INFO-TECH CITROËN Racing C2 R2 MAX N° 17A/09.

Subject : Engine loom, motorised throttle connector .

**Tie rap assembly over the
locking pin**

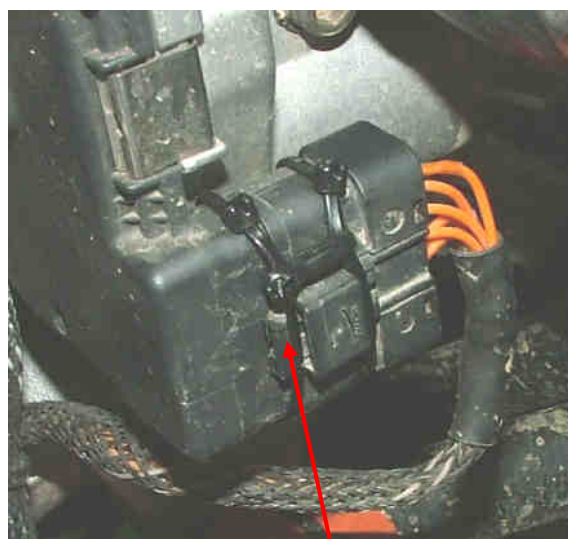
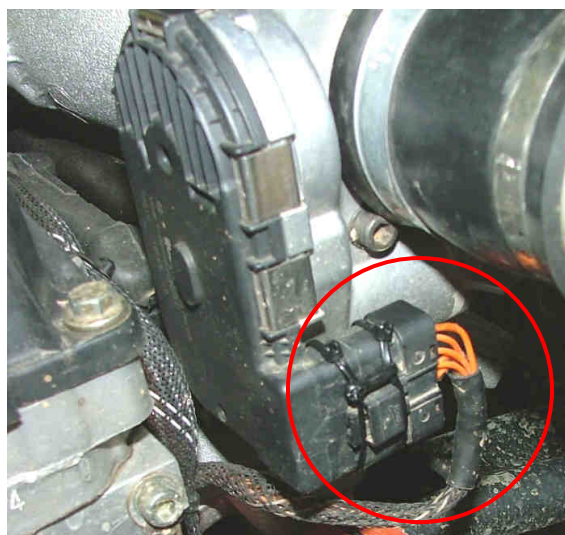
An error was done in the last *infotech N°17/09*, May the 5th, 2009.

The tie rap on throttle body side (shown on pictures below) was tightened below the locking pin of the throttle connector. This way, a disconnection of the connector was potentially possible.

So, we suggest you to assembly the tie rap over the connector locking pin, as shown on pictures below :
